Agenda item: 7.2.5 WG2 Approval of independent CRs to Release 5
Source: Panasonic
Title: Comment to 25.321CR173r1 UE procedure for TB Size signaling
Document for: Discussion

Figure of hybrid ARQ functionality in RAN1

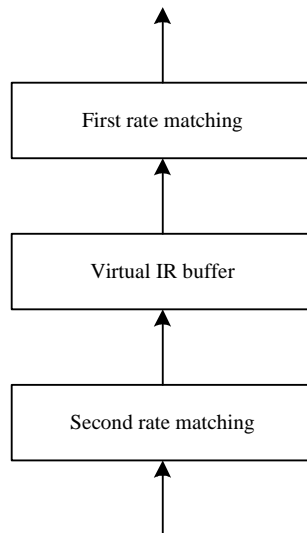
In 25.212, HARQ functionality is described. The two stage rate matching shown in following figure coordinates the number of bits in each stage.

The first rate matching stage matches the number of input bits to the virtual IR buffer, information about which is provided by higher layers. The second rate matching stage matches the number of bits after first rate matching stage to the number of physical channel bits available in the HS-PDSCH set in the TTI.

To process second rate matching, the number of systematic bits is required. The number of systematic bits is known by transport block size. Therefore, UE cannot process second rate matching when the transport block size index value is 111111 and New Data Indicator has been incremented. It looks RAN1's virtual IR buffer and RAN2's soft buffer is NOT equivalent.
